PROJECT REVIEW COMMITTEE - CITY OF WILDWOOD

Agenda

February 13, 2024 10:00 AM

SHEET NO.
C1.4

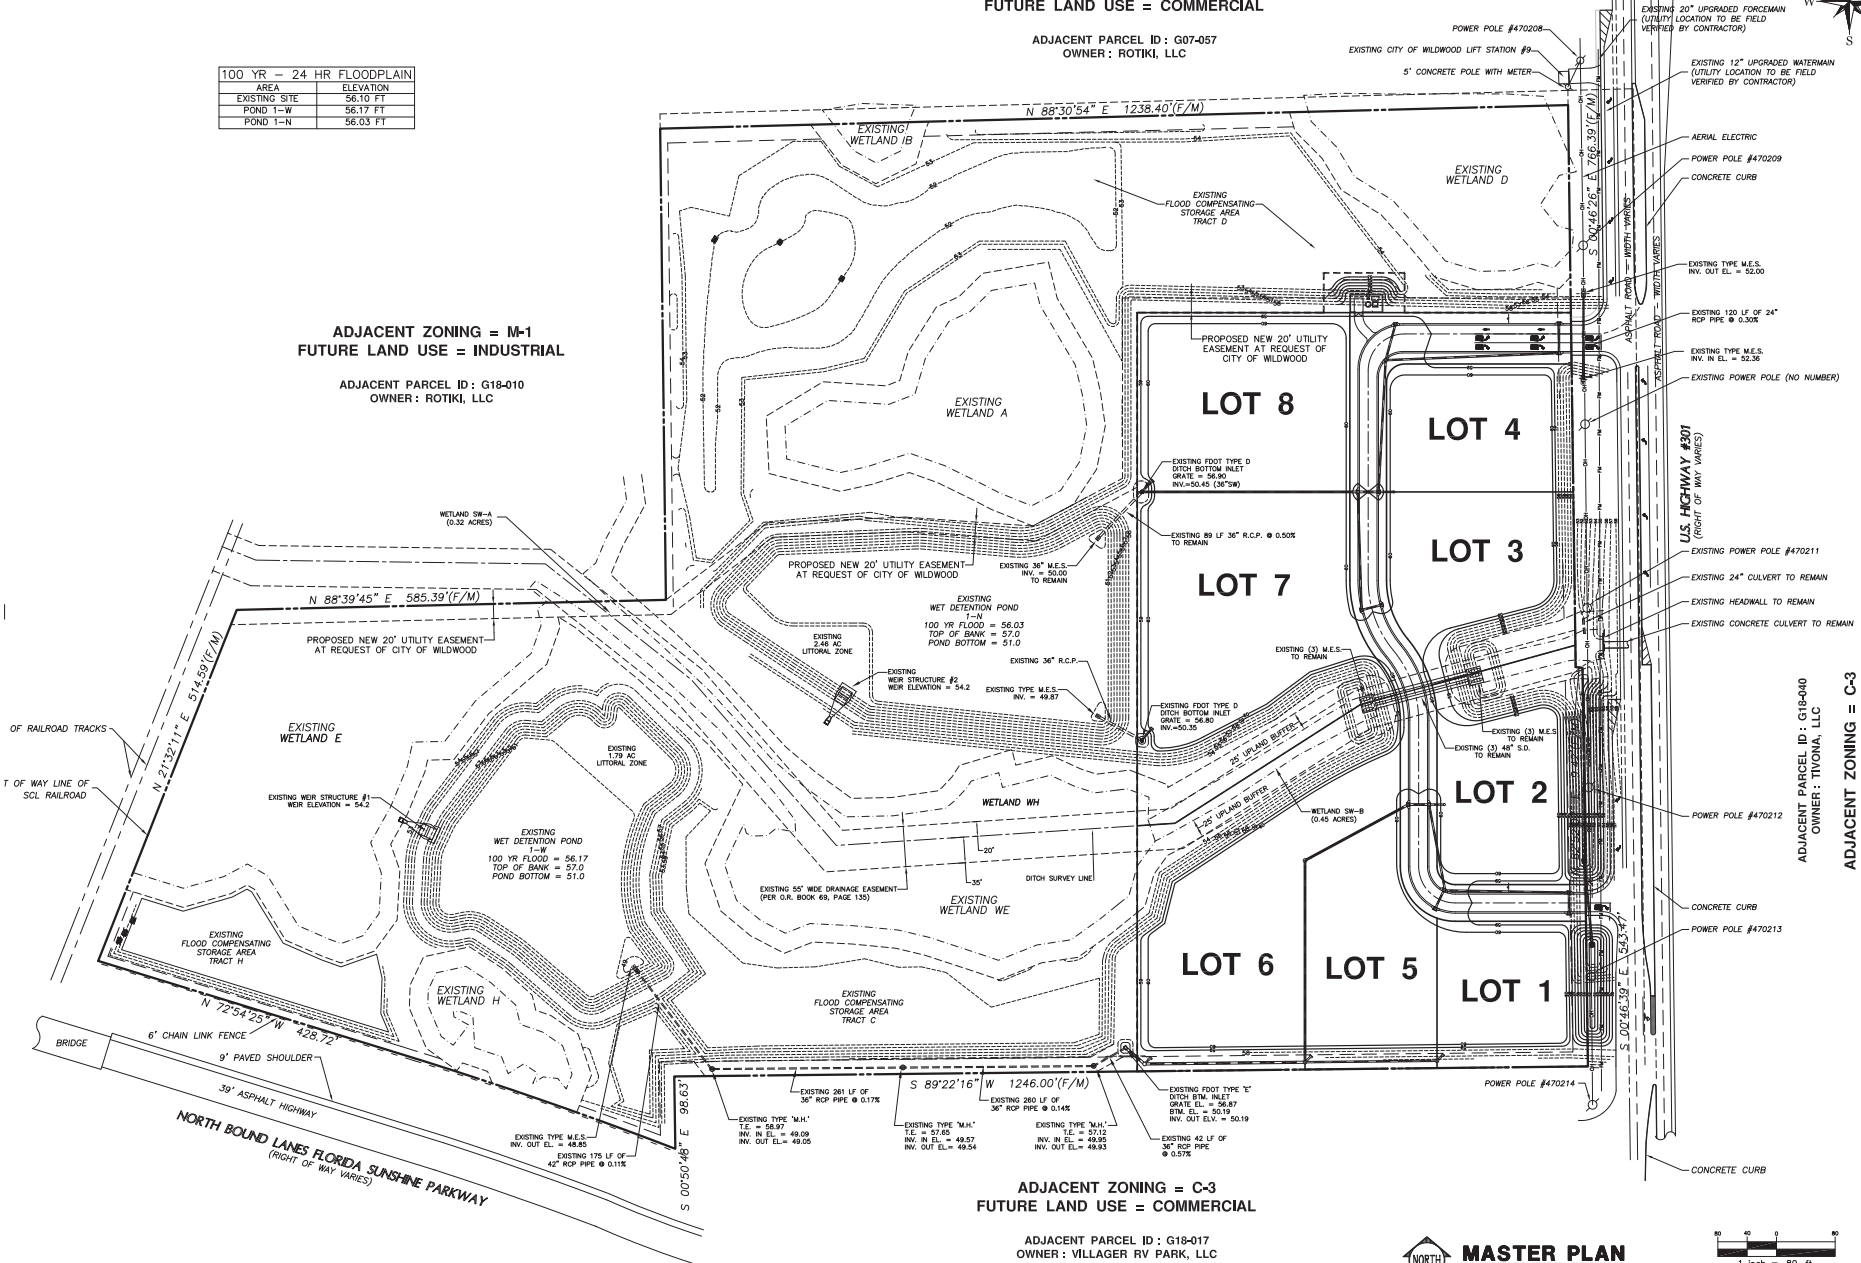
1. Sheet C4.1: At the north entrance the proposed water main and force main are inside the easement. Relocate the water main to the right of way for future room in the easement for additional lines.
